Access Compliance Report

Public Rights-of-Way

(Curb Ramps)

Intersection ID: 9686	Main Street: N_TRYON_ST	Cross Street: W_31ST_ST	Location: W
ADA ID: CA9F49FE04F6	Ramp Type: PerpDiag	Initial Pass/Fail: Fail	Overall Compliance: No
Severity Score: 22.5			
Codes/Mitigation Info/Possible Solution		Field Measurements/Component Compliance

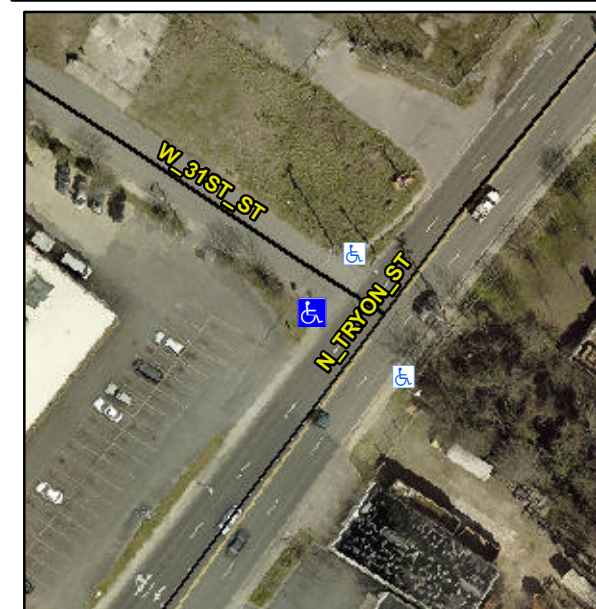
Not Found, R304.5.1, R304.2.2, R304.5.3

Compliance	Description	Data	Compliance	Description	Data
N/A	Ramp Length (in)	62.5	No	Ramp Slope (%)	8.8
No	Ramp Width (in)	41.0	No	Ramp XSlope (%)	2.6
N/A	Flare Type LT	N/A	N/A	Flare Type RT	N/A
N/A	Flare Slope LT (%)	N/A	N/A	Flare Slope RT (%)	N/A
N/A	Flare Traversable LT?	N/A	N/A	Flare Traversable RT?	N/A
N/A	Landing Length (in)	N/A	N/A	DWS Provided?	N/A
N/A	Landing Width (in)	N/A	N/A	DWS Contrast?	N/A
N/A	Landing Slope (%)	N/A	N/A	DWS Length (in)	N/A
N/A	Landing X Slope (%)	N/A	N/A	DWS Full Width?	N/A
N/A	Landing Curb? (Y/N)	N/A	N/A	DWS Offset (in)	N/A
N/A	Shared Landing?	N/A			
N/A	Gutter Ponding?	N/A	N/A	Gutter Slope (%)	N/A
N/A	Gutter Lip Ht (in)	N/A	N/A	Gutter X Slope (%)	N/A
N/A	Painted X Walk1?	No	N/A	Painted X Walk2?	No
	X Walk 1 Direction	To SE		X Walk 2 Direction	To NE
N/A	X Walk 1 Width (in)	N/A	N/A	X Walk 2 Width (in)	N/A
	X Walk 1 Slope (%)	3.3		X Walk 2 Slope (%)	4.1
	X Walk 1 X Slope (%)	0.5		X Walk 2 X Slope (%)	3.3

Remove & Replace Curb Ramp With Two New Directional Ramps or Equivalent.
